Subject : Response to the FCC Correspondence Reference # 13808 for Additional Information for RIM DataTAC handheld radio device FCC ID: L6AR857D-2-5, 731 Confirmation # EA97380

Re: Questions from the FCC

FCC ID:	**L6AR857D-2-5**
Correspondence Reference Number:	**13808**
731 Confirmation Number	**EA97380**
Date of Original E-Mail:	**05/03/2000**

Figure 1. Side view of holster

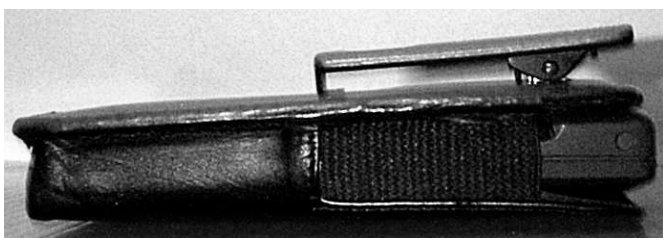
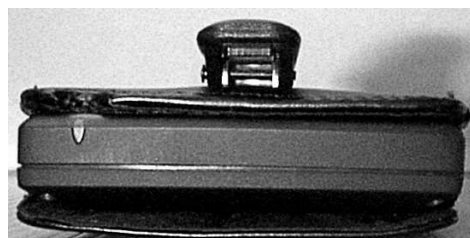
> **> 2.** Device has a belt-clip/holster, please confirm that there is no metallic component in the assembly of this accessory that could affect SAR and upload a photo of this accessory.

The belt-clip/holster does have metallic components in the assembly of this accessory that could possibly affect SAR (Figures 1 and 2). Figure 3 shows the holster beside a Proton handheld – note the notch in the top of the case to the right side of the clip. The handheld is intended to be inserted into the holster (Figure 4) with the keyboard facing the clip so that the small LED indicator fits into this notch (see left side of Figure 2).
